Chik-fil-A Hwy 95 at Lake Mead

CITY OF LAS VEGAS		DATE:
INTER-OFFICE MEMORANDUM		January 2, 2018
TO: Land Development Services Department of Building & Safety		FROM: Albert Sung, P.E. Flood Control Project Engineer Department of Public Works
SUBJECT:	Drainage Study for:	
	Chik-fil-A Hwy 95 at Lake Mead	
Cross Streets:	SWC of Lake Mead Blvd & Rainbow Blvd	Chik-fil-A, Inc.
File Number:	F:\Depot\DSMemos\DS4940A.doc	Bart Anderson, P.E., DevCo
Parcel Number:	138-22-713-002	
Zoning Action:	SDR-71994	
FEMA Flood Zone	YES NO X	
Proposed Storm Drain	YES NO X

TECHNICAL DRAINAGE STUDY for
Chik-fil-A HWY 95 at Lake Mead

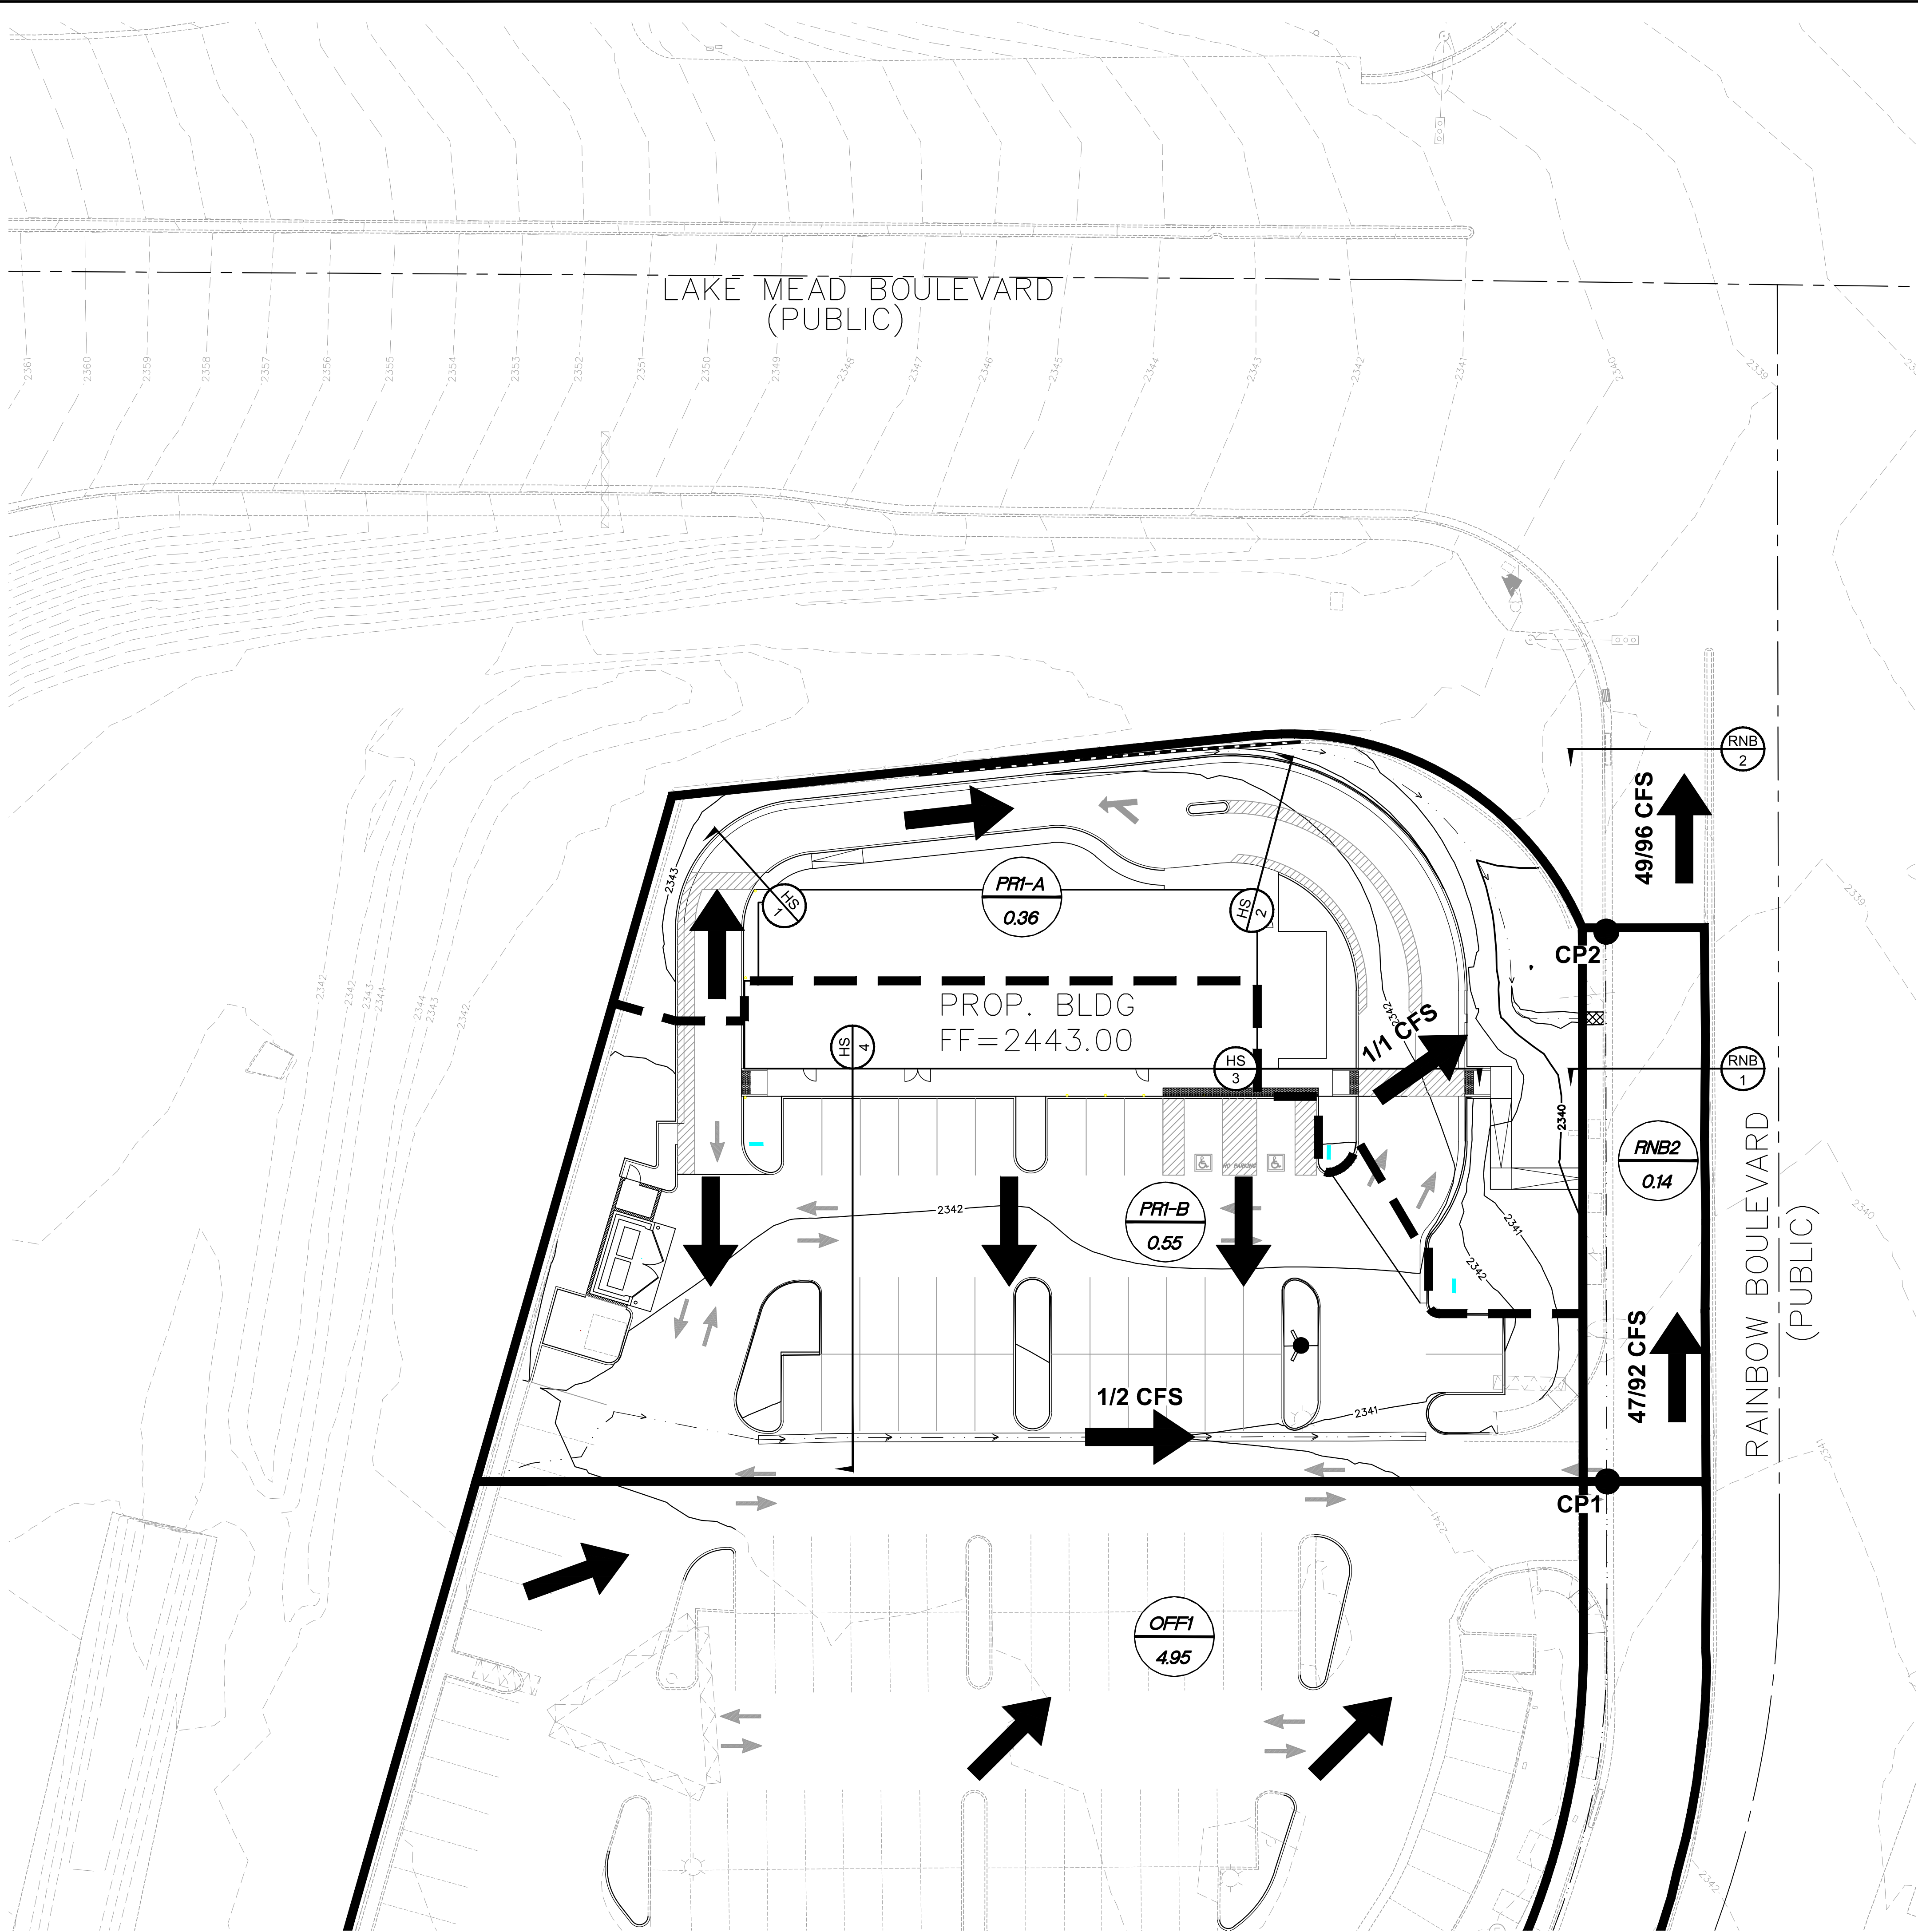
1. The Q100 flow value of 96 cfs indicated on Figure PR-1 Proposed Condition Basin Map does not match the hydrologic results and summary tables.
2. Revise Construction Note 6 to reference sheet C4.3.
3. Label the APN of the subject site on the Grading Plans.
4. Identify and label the existing storm drain facilities within Rainbow Boulevard (CLV #107-V3519) as well as within the common lot between the subject site and Lake Mead Boulevard.
